Access Compliance Report

Public Rights-of-Way

Intersection ID: 3352	Main Street: DAVIS_RIDGE_DR	Cross Street: FALLS_RIDGE_LN	Location: SE
ADA ID: 91311EF46083	Ramp Type: PerpDiag	Initial Pass/Fail: Fail	Overall Compliance: No
Severity Score: 10			
Codes/Mitigation Info/Possible Solution		Field Measurements/Component Compliance

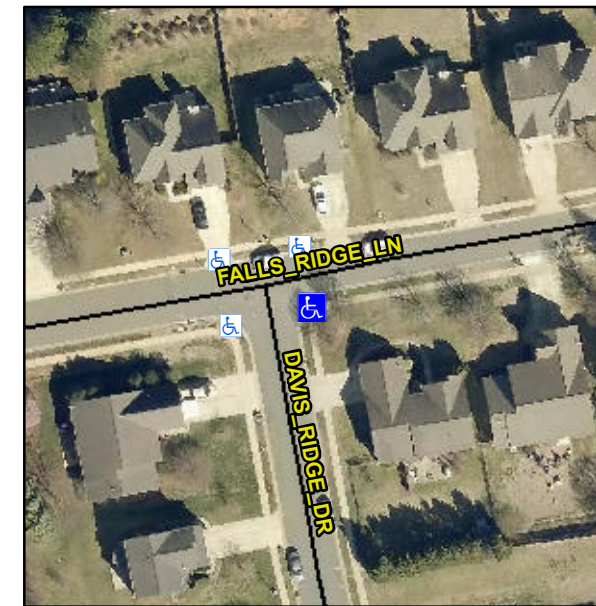
R304.5.1, R304.5.3

Compliance	Description	Data	Compliance	Description	Data
N/A	Ramp Length (in)	49.0	Yes	Ramp Slope (%)	6.7
No	Ramp Width (in)	47.0	No	Ramp XSlope (%)	3.3
N/A	Flare Type LT	N/A	N/A	Flare Type RT	N/A
N/A	Flare Slope LT (%)	N/A	N/A	Flare Slope RT (%)	N/A
N/A	Flare Traversable LT?	N/A	N/A	Flare Traversable RT?	N/A
N/A	Landing Length (in)	N/A	N/A	DWS Provided?	N/A
N/A	Landing Width (in)	N/A	N/A	DWS Contrast?	N/A
N/A	Landing Slope (%)	N/A	N/A	DWS Length (in)	N/A
N/A	Landing X Slope (%)	N/A	N/A	DWS Full Width?	N/A
N/A	Landing Curb? (Y/N)	N/A	N/A	DWS Offset (in)	N/A
N/A	Shared Landing?	N/A			
N/A	Gutter Ponding?	N/A	N/A	Gutter Slope (%)	N/A
N/A	Gutter Lip Ht (in)	N/A	N/A	Gutter X Slope (%)	N/A
N/A	Painted X Walk1?	No	N/A	Painted X Walk2?	No
	X Walk 1 Direction	To N		X Walk 2 Direction	To W
N/A	X Walk 1 Width (in)	N/A	N/A	X Walk 2 Width (in)	N/A
	X Walk 1 Slope (%)	4.9		X Walk 2 Slope (%)	6.3
	X Walk 1 X Slope (%)	3.4		X Walk 2 X Slope (%)	2.3

N/A	Ramp inside XWalk1?	N/A	N/A	Ramp inside XWalk2?	N/A
	Road Slope (%)	5.8	N/A	Clear Space?	N/A
	Road X Slope (%)	7.2	N/A	Clear Space to XWalk (in)	N/A
N/A	Any Obstructions?	N/A	N/A	Storm Grate/Utility Hazard?	N/A
	Obstruction Type			Storm Grate/Utility Type	
		N/A			N/A
		Yes		Surface Condition? (G/P)	Good

Remove & Replace Curb Ramp With Two New Directional Ramps or Equivalent.
